Figure 2: Correct Pin1 Identifier of J2

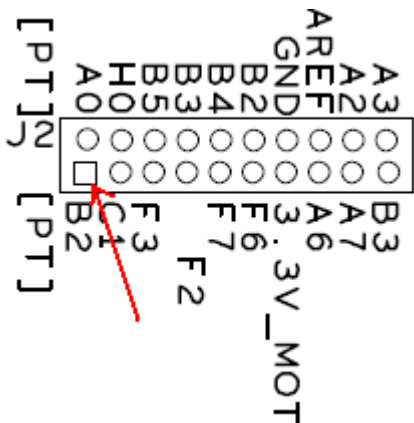
The correct position should be:

All the pin names are correct. This pin1 identifier error will not impact any functions of the board.

Fix Plan: Has fixed on FRDM-KE02Z (700 Assembly Rev A) without TDA4613.
